R706

PROCESSOR TYPE PDP-8 FAMILY

ENGINEERING CHANGE ORDER

CHANGE NO. VT01-05014

5409154, T4

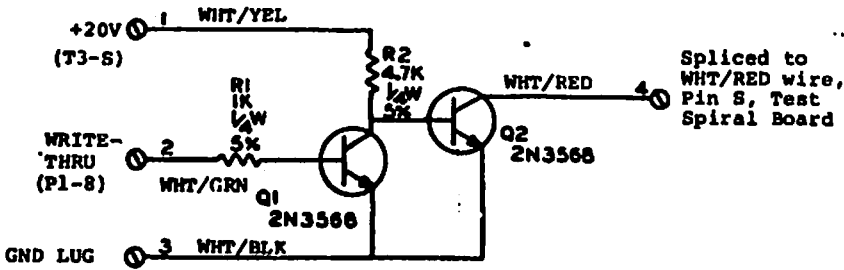
Spliced to wire removed from
